FTTM Change Summary for Comment Resolutions

Richard Tse
June 5, 2024

Change FTTM inputs from “domain” to “time”

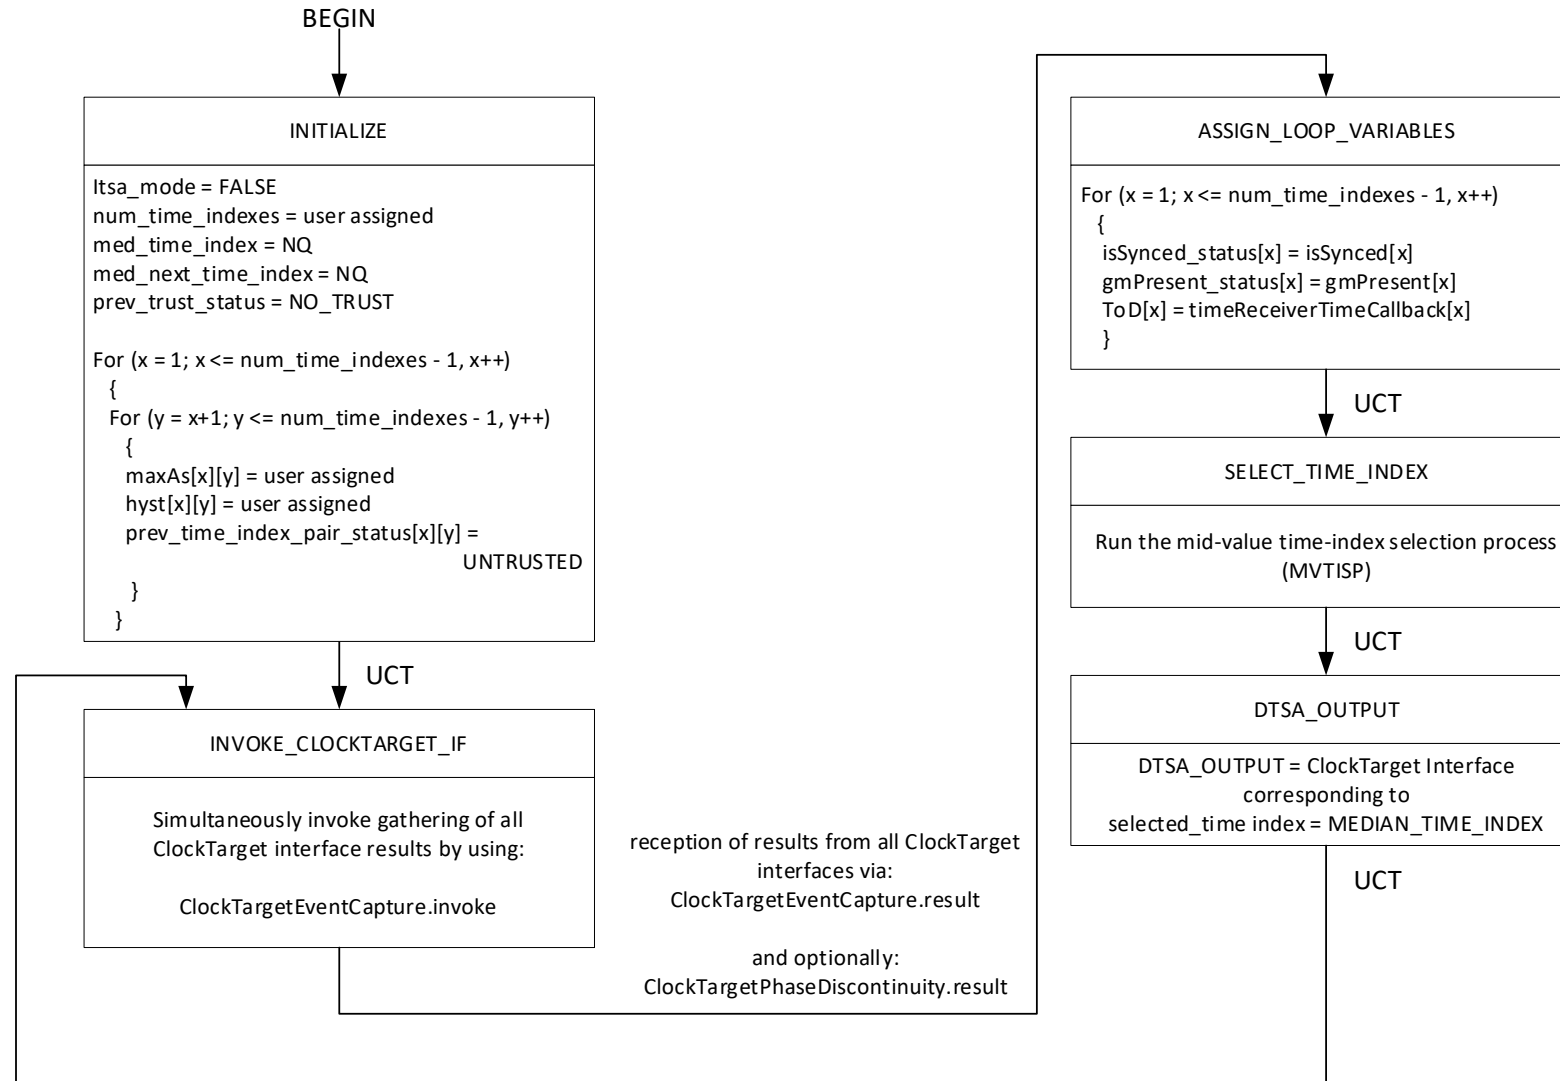
- Functional block diagram redrawn
- DDSA renamed to DTSA
- IDSA renamed to ITSA

Default DTSA state machine

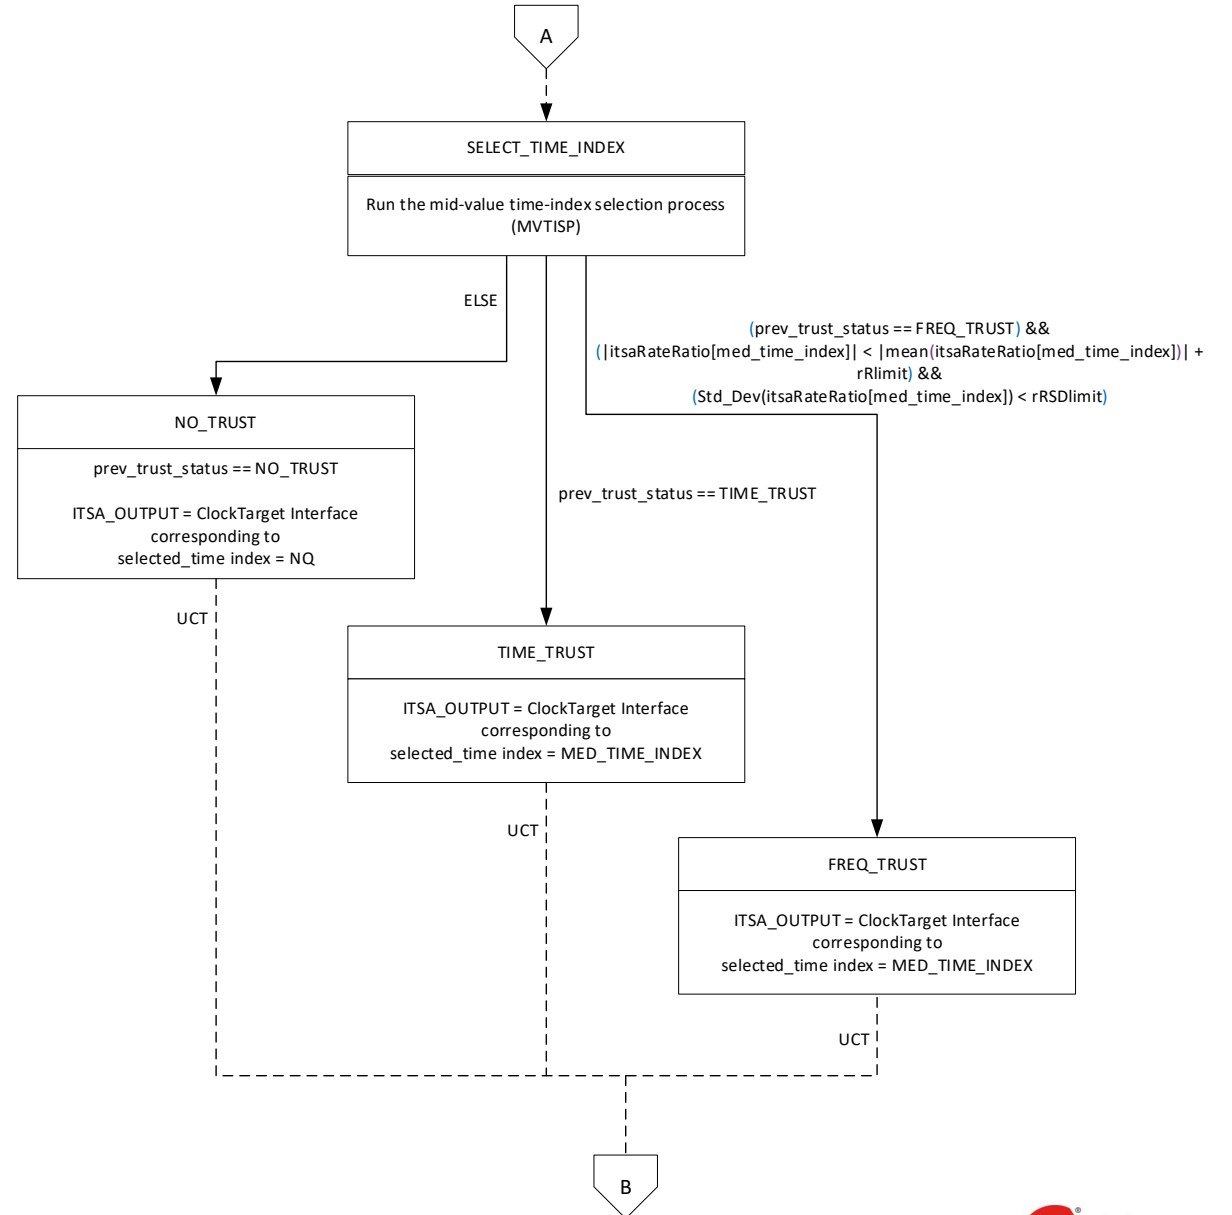
- **Use 802.1Q's state-machine structure**
 - New state-machine defined for default DTSA
 - New state-machine defined for default ITSA
 - Formerly called the default FTTM state-machine
 - Mid-value time-index selection process (MVTISP)
 - Has no states
 - Is run in the SELECT_TIME_INDEX state of the new default DTSA/ITSA state-machines
 - Is shown by pseudo-code
- **States are atomic without infinite looping**
 - Default DTSA/ITSA state machines use the ClockTargetEventCapture application interface
 - ClockTargetEventCapture.invoke events are used to gather new time information (via ClockTargetEventCapture.response) and start a new round of state transitions
